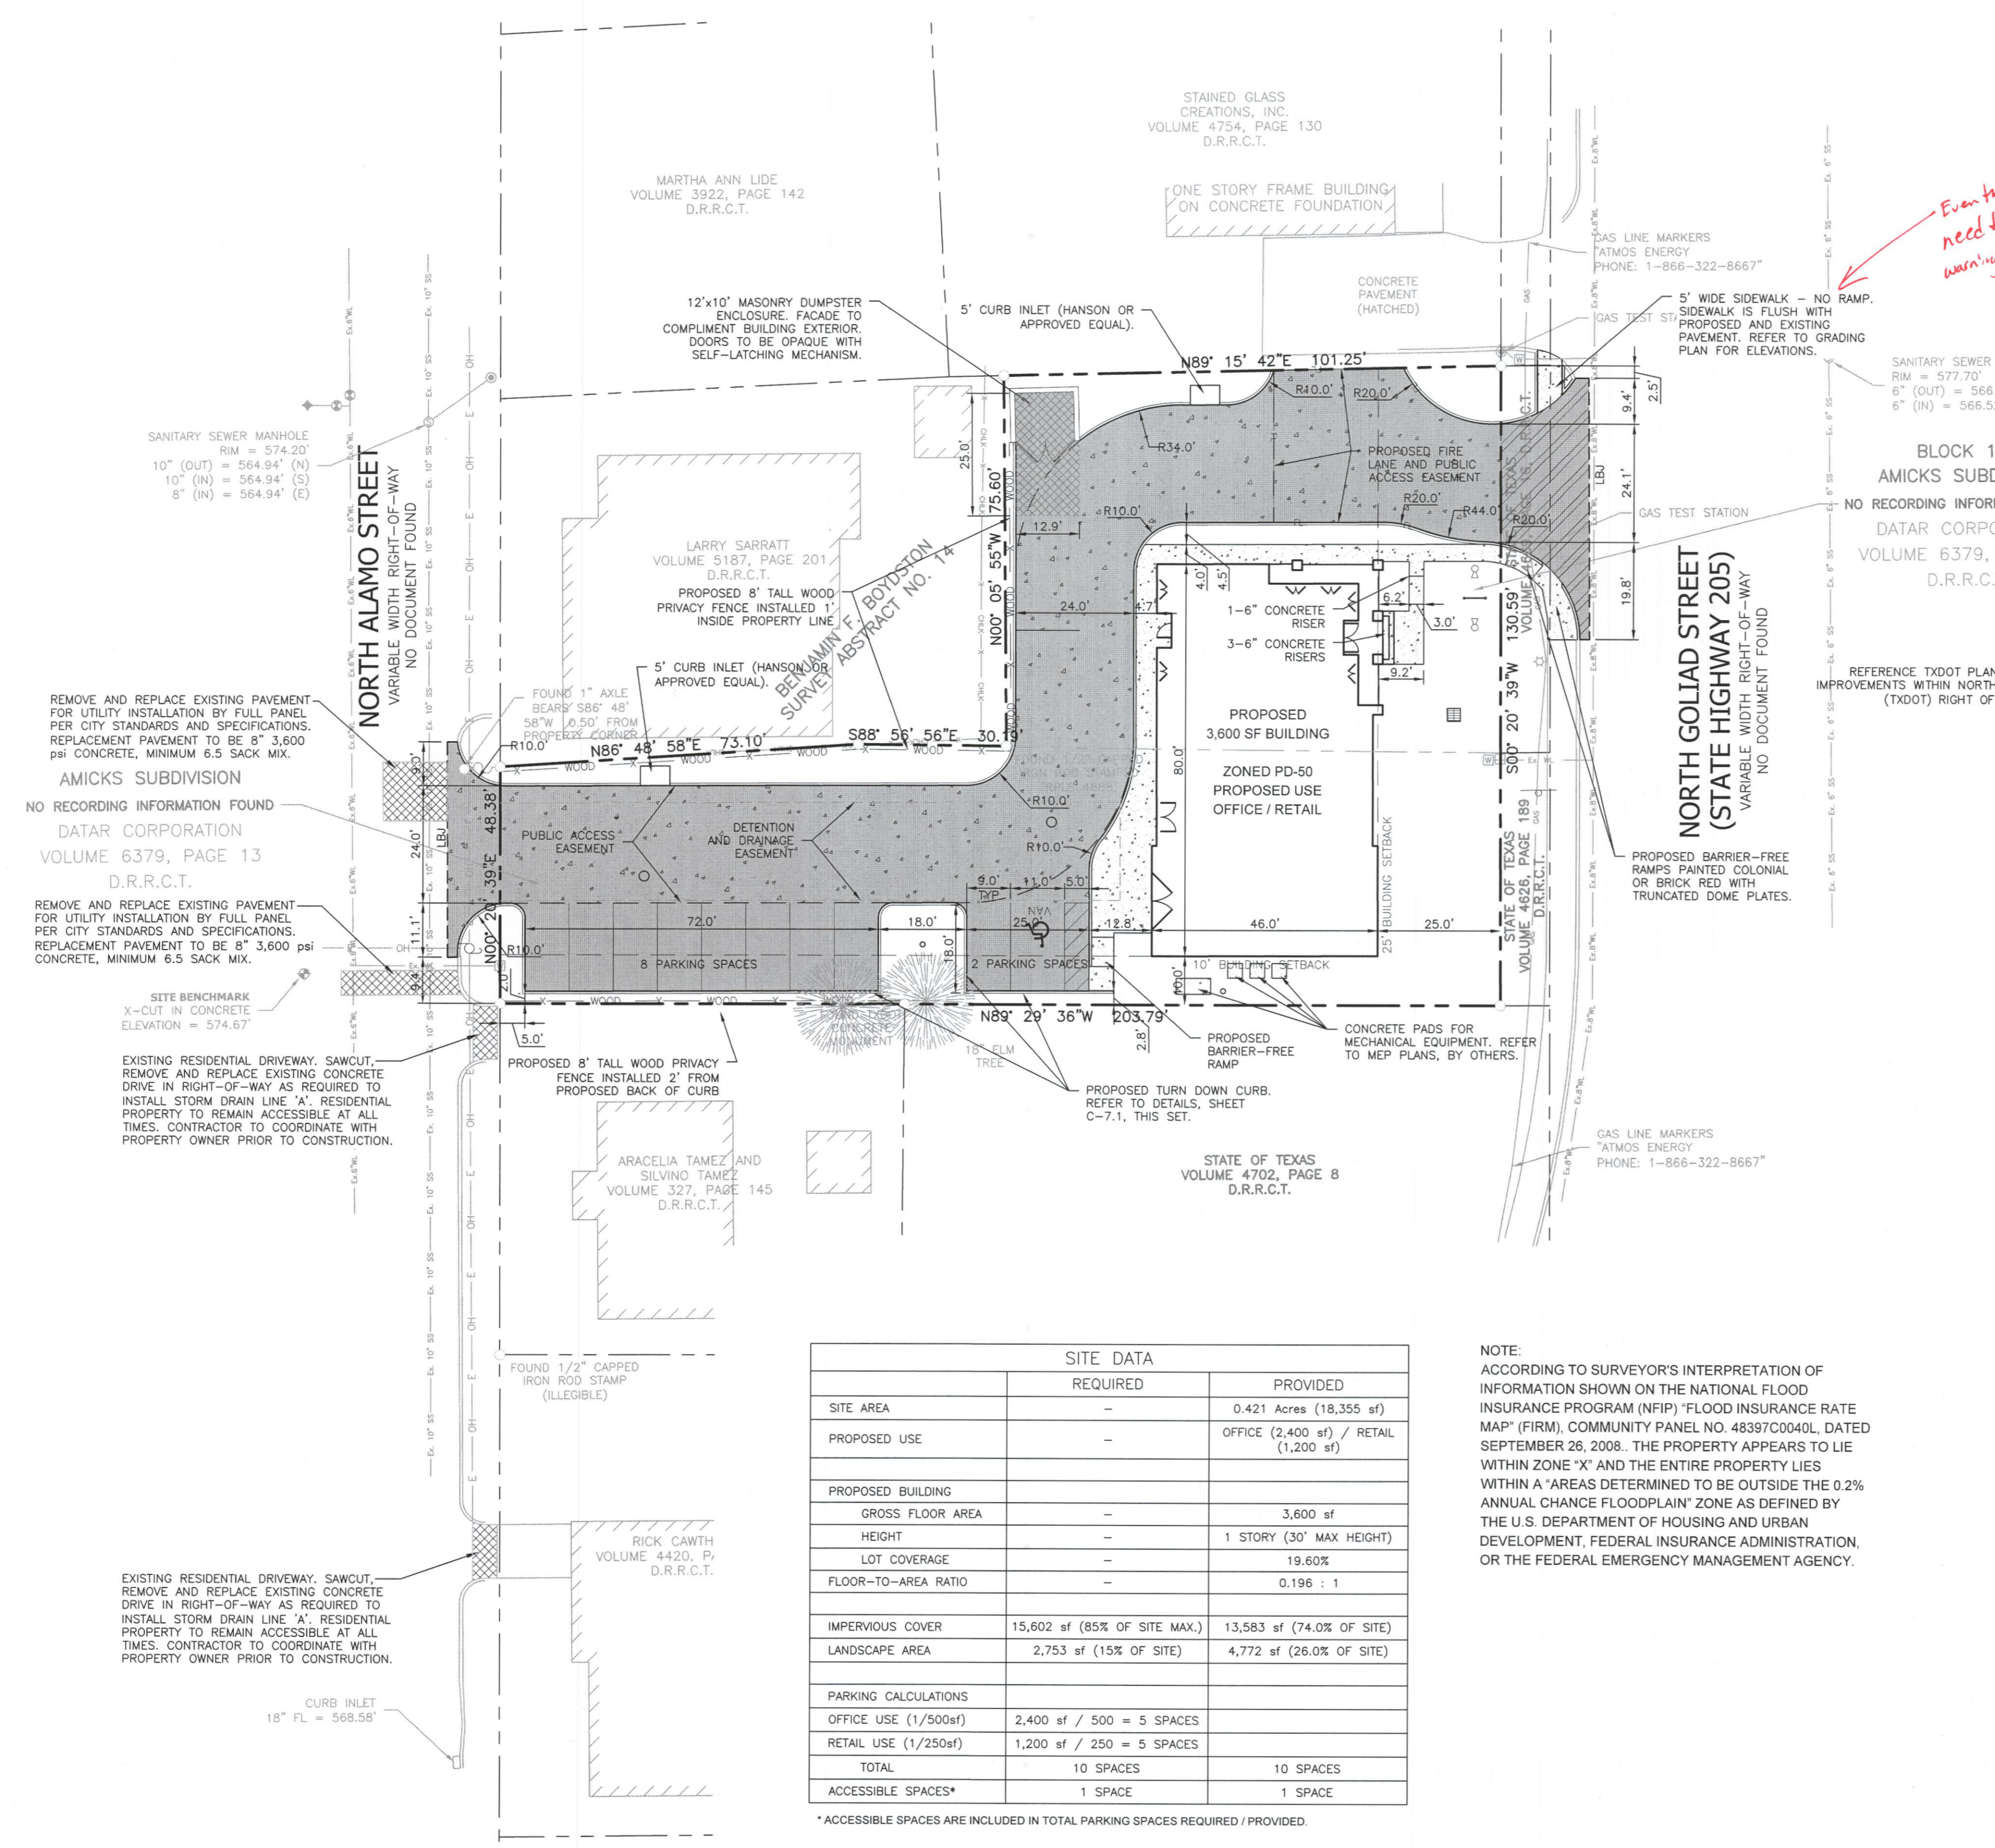
No sand under pavement

Even though flush with driveways need to provide truncated dome warning pad for each drive
